**ECR#: P17**

**Title: Correct Gold Finger Tolerance**

**Spec Version: NLX Motherboard Specification 1.2**

**Figure 3.10: NLX Card Edge Detail**

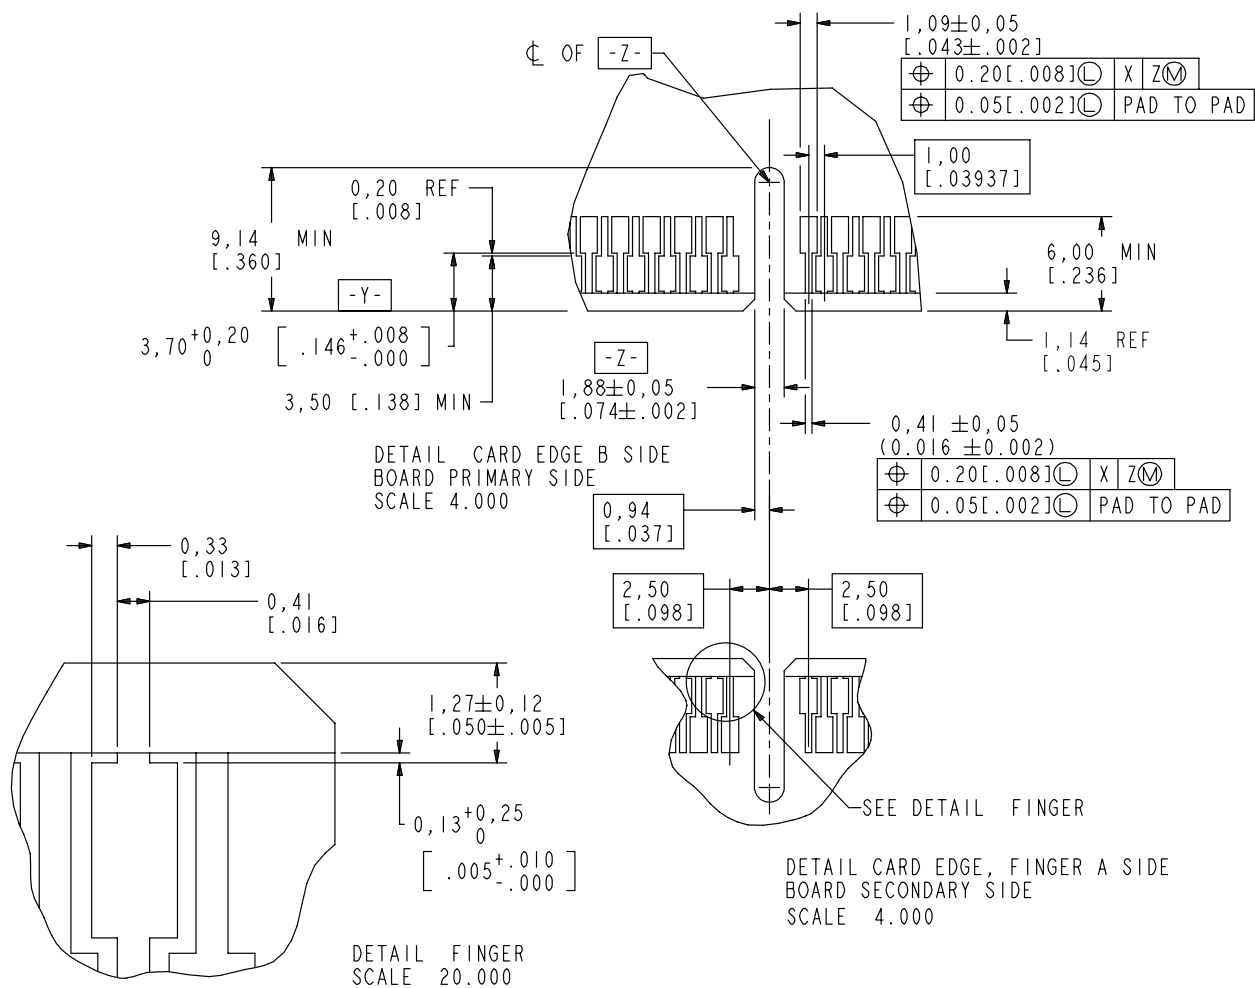
1. Dimensioned with GDT (Geometric Dimensions and Tolerances) per ANSI Y14.5M.
2. See Figure 3.11 for pin location details.
3. Added detail view "Finger" with configuration to eliminate swipe while cutting chamfer.
4. Added key slot tolerance under Z.

**Figure 3.11: NLX Card Edge, Board View**

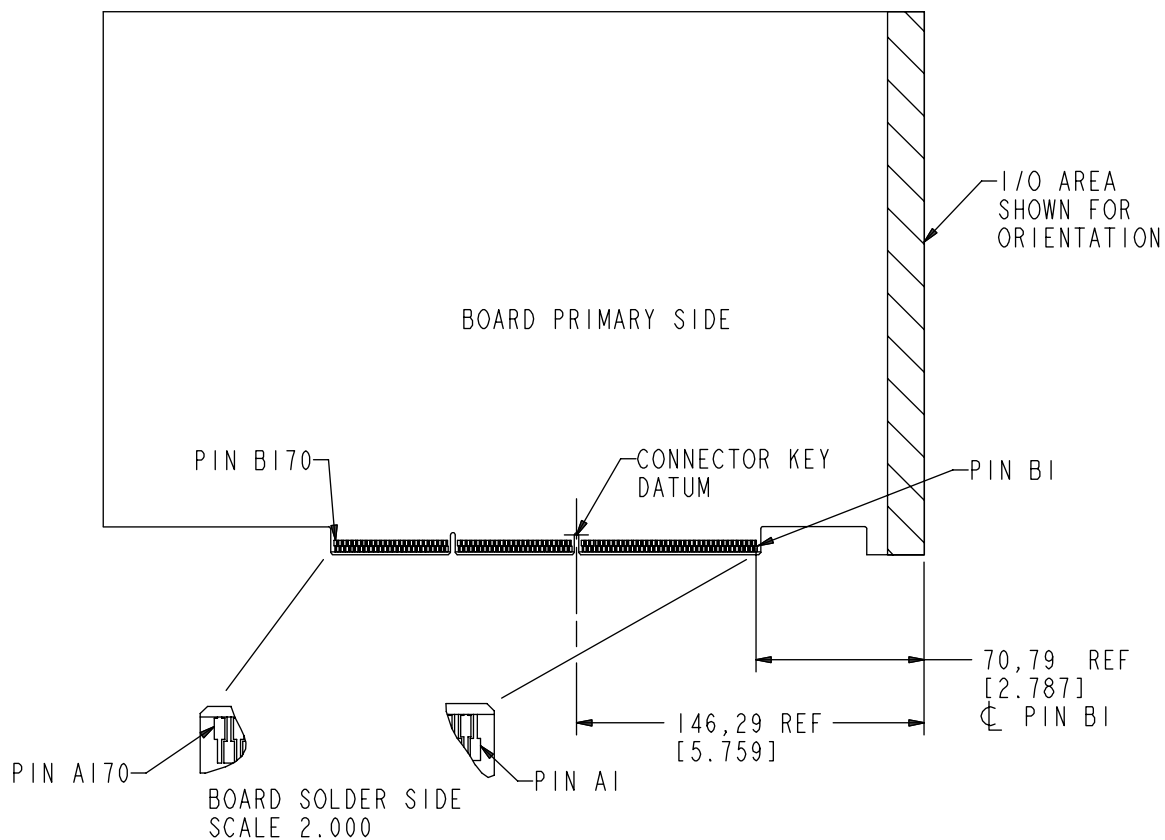
1. Picture update shows chamfer.
2. Added pin number and location reference details.
